Subject: AP1000 COL Standard Technical Report Submittal of APP-GW-GLR-005, Revision 1 (TR 9)

APP-GW-GLR-005, Revision 1

“Containment Vessel Design Adjacent to Large Penetrations”

Containment Vessel Design Adjacent to Large Penetrations

Figure 3.8.2-7
Finite Element Model for Large Penetration Local Analyses

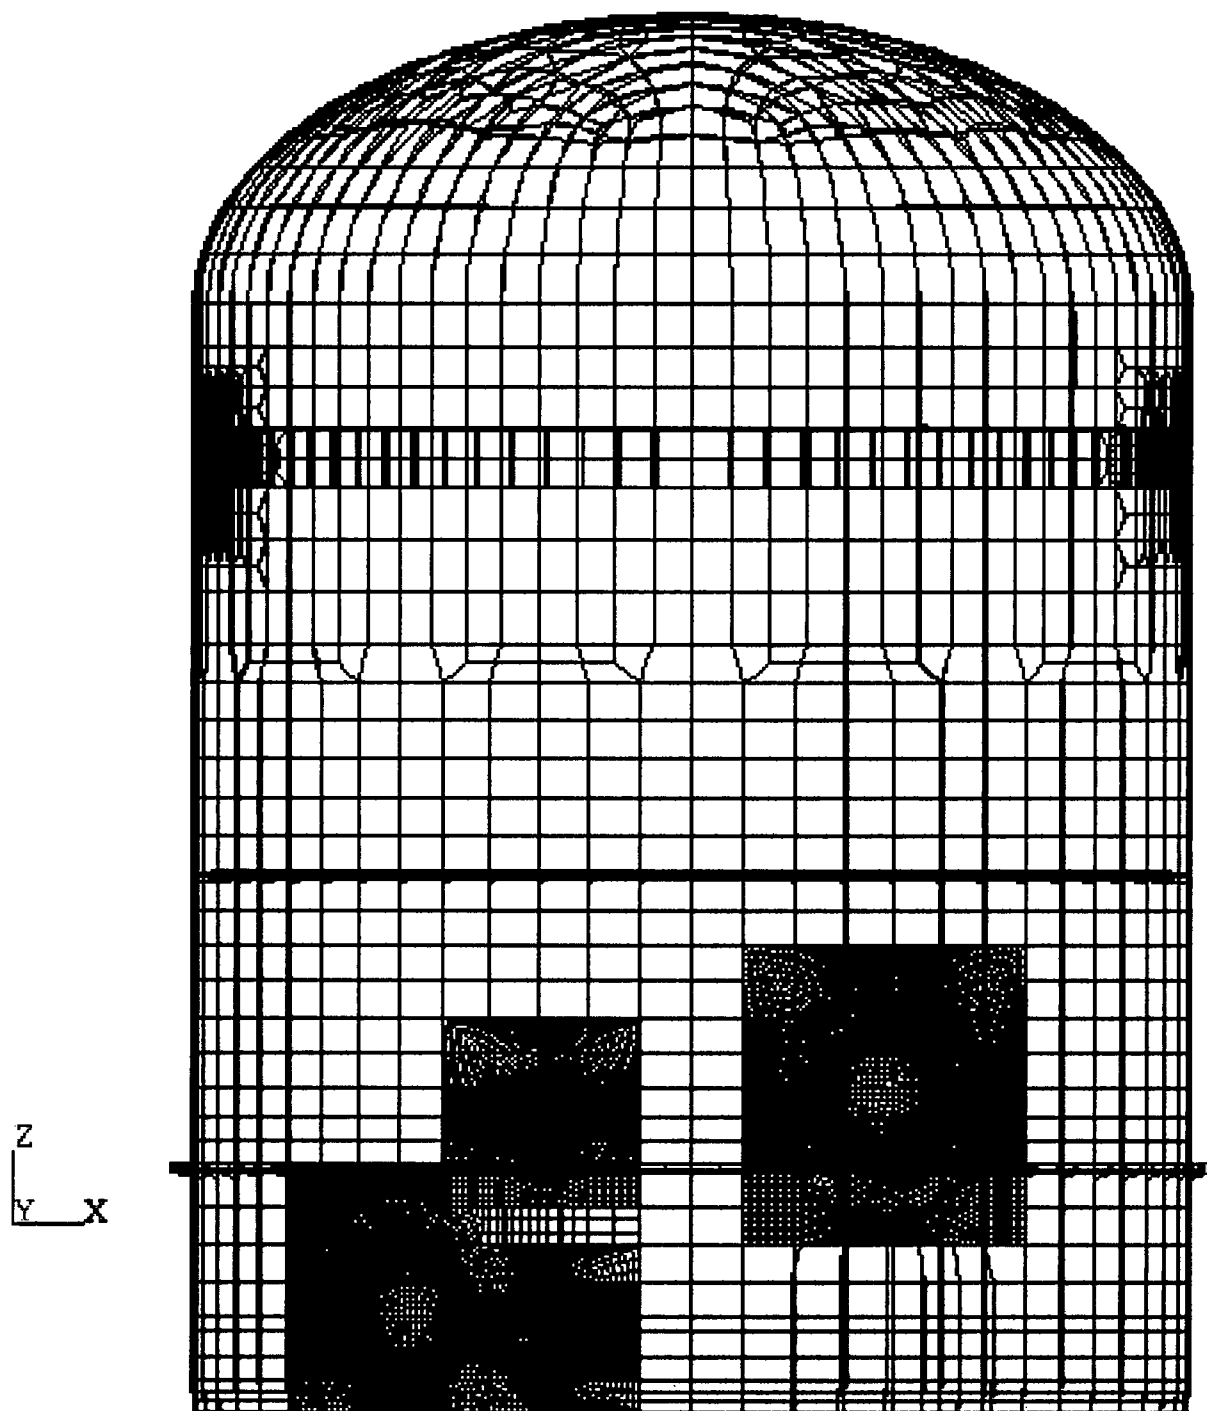
1. Service limit levels are per ASME-NE.
 2. Where any load reduces the effects of other loads, that load is to be taken as zero, unless it can be demonstrated that the load is always present or occurs simultaneously with the other loads.
 3. **Reduced pressure of 0.9 psid at one hour in loss of all AC transient in cold weather**
 4. **Temperature of vessel is 70F**
 5. **Temperature distribution for loss of all AC in cold weather**
- Replace Figure 3.8.2-7 by the figure below

Figure 3.8.2-4 (Sheet 2 of 6)
Containment Penetrations Startup Feedwater

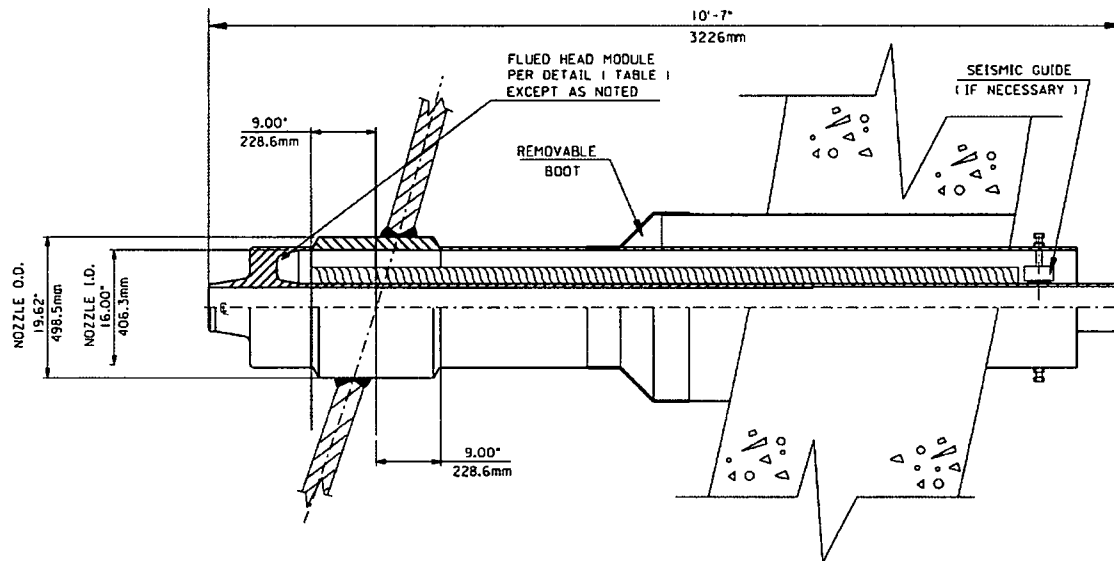
Revise sheets 2, 3, 4 and 6 of Figure 3.8.2-4 as shown on the following pages to reflect detail design of the penetration reinforcement.

Figure 3.8.2-4 (Sheet 4 of 6)
Containment Penetrations

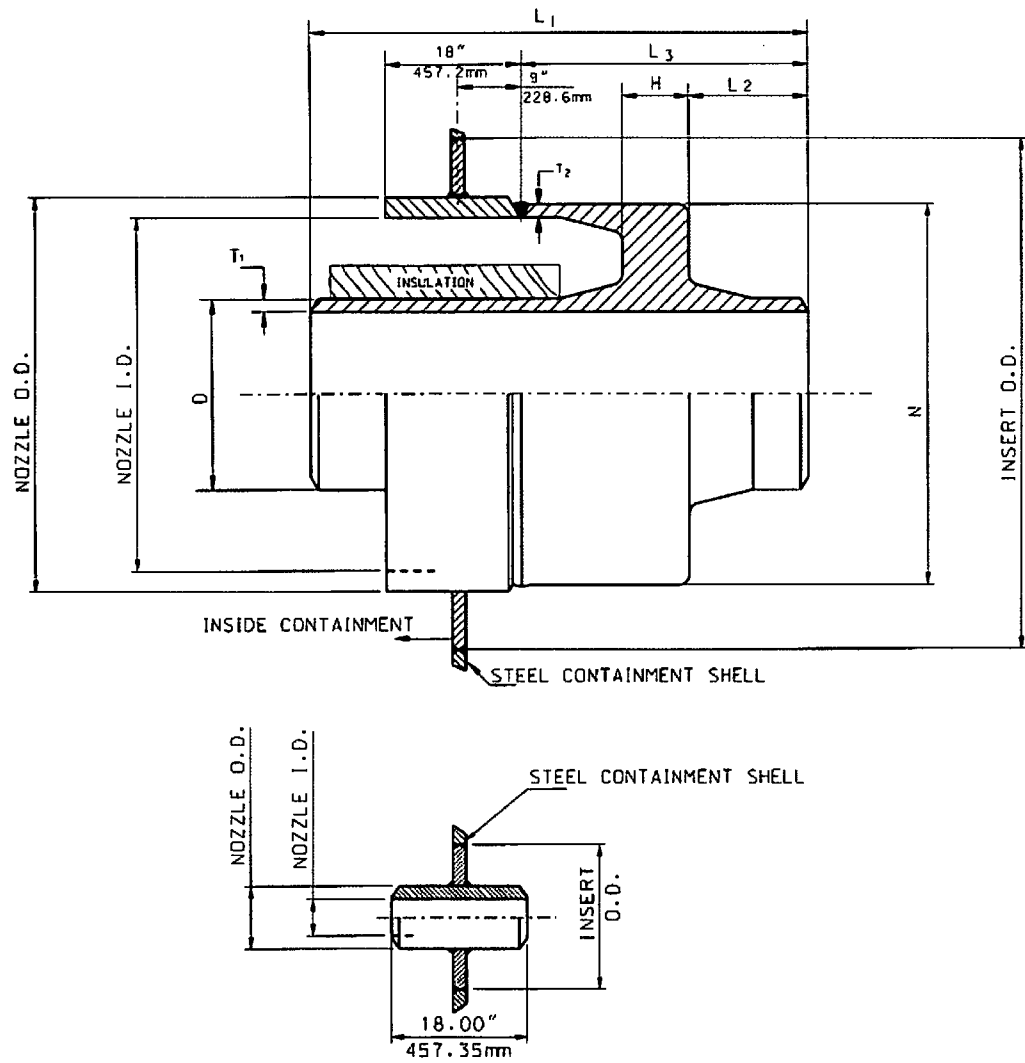
Revise classification in Table 3.2.3 as shown below from MC to Class 2 for penetrations where the process pipe penetrates directly the containment vessel without the use of a flued head (see typical detail on lower half of Figure 3.8.2-4, sheet 4 of 6). In this case the sleeve is a boundary of the process fluid and is required by the ASME Code to be Class 2.
